Service Bulletin

S.B. No: 163

Title: INSPECTION OF FUEL VALVE TORQUE SHAFT UNIVERSALS

Applicability: T67C Post Mod M156, T67M-MkII, T67M200, T67M260 and T67M260-T3A Pre Mod M830

FIG. 1 FUEL SELECTOR VALVE SHAFT DETAIL (T67M260, T67M260-T3A)

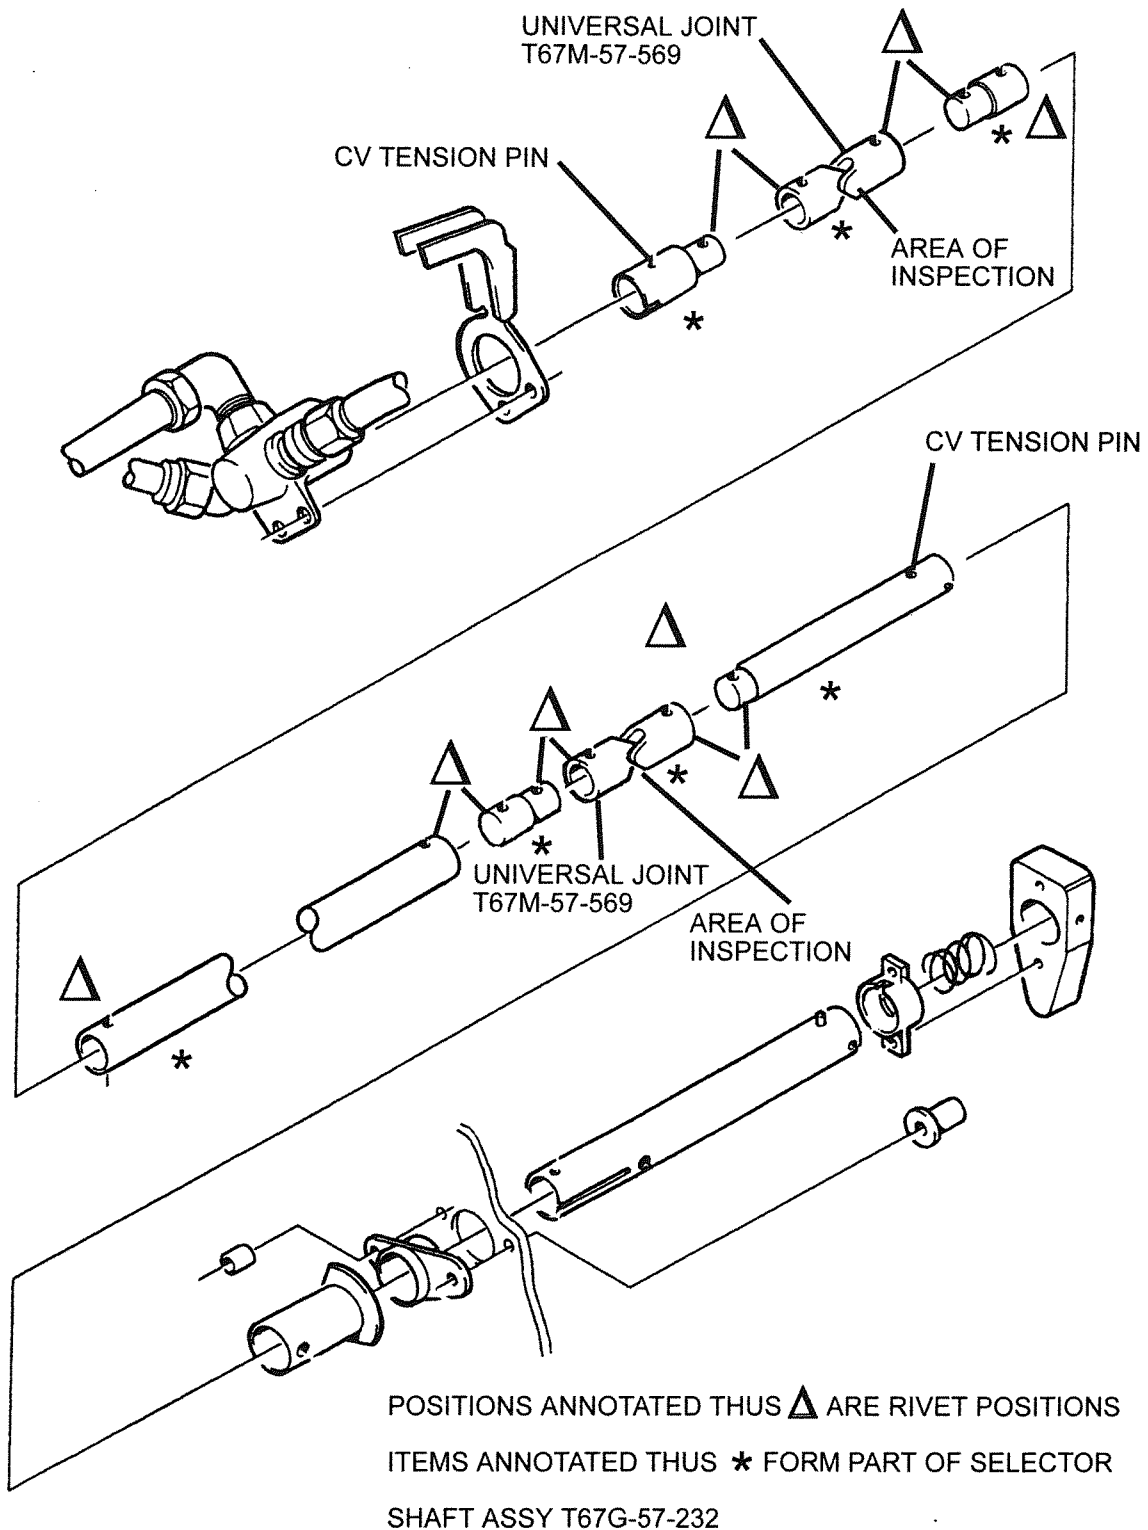
1. At the next 150 hour check (or 100 hour check) gain access to the fuel selector valve torque shaft situated behind the forward console fascia. Ref Fig. 1 and Fig. 2.
2.
 - i) Inspect the pivot area of the universal joint/s for wear; do not use excessive force.
 - ii) Inspect the pivot area of the universal joint/s for physical damage e.g. splayed forks, hammer marks, pivot pin damage, using torch and mirror.
3. If no evidence of wear or physical damage are found, annotate logbook "SB163 accomplished".
4. a. T67M260 and T67M260-T3A

If there is any evidence of wear or physical damage then remove the torque shaft assembly T67G-57-232 and replace either the torque shaft assembly or the relevant universal joint (T67M-57-569) on the shaft. Reassemble torque shaft assembly back into the aircraft. Annotate logbook "SB163 accomplished".

**FIG. 2 FUEL SELECTOR VALVE SHAFT DETAIL
(T67C POST MOD M156, T67M-MKII, T67M200)**

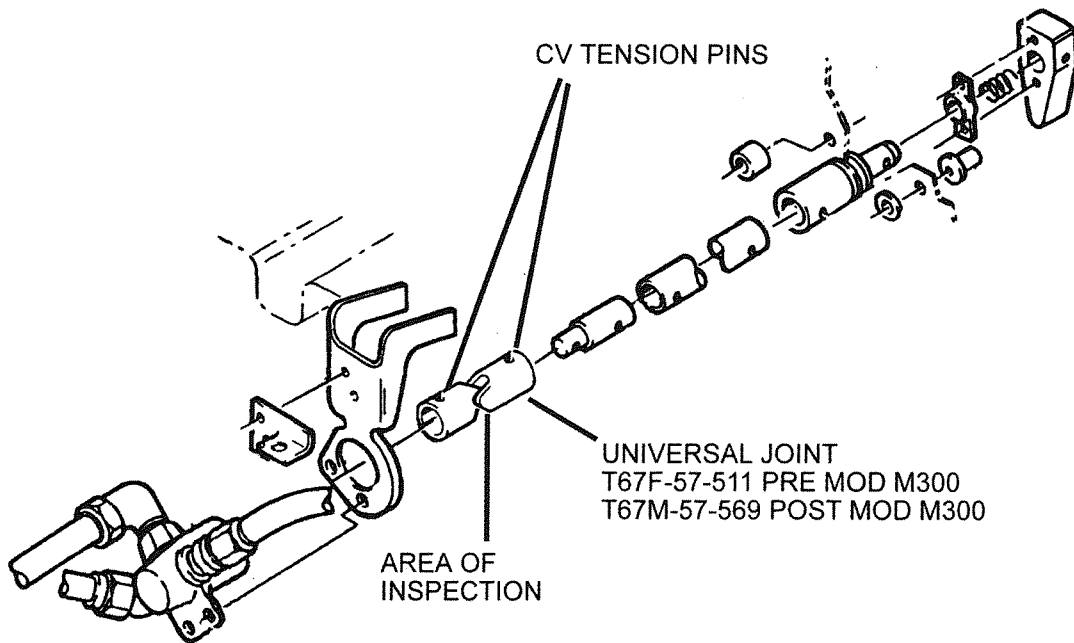
If there is any evidence of wear or physical damage to the universal joint then remove the universal joint, (T67F-57-511 Pre Mod M300, T67M-57-569 Post Mod M300) from fuel selector valve and shaft adapter assembly. Reassemble back into aircraft new relevant universal joint.

6. T67C Post Mod M156, T67M-MkII and T67M200 only: IPC is incorrectly drawn ref universal joint. Figure 2 shows correct configuration. IPC will be amended in due course.
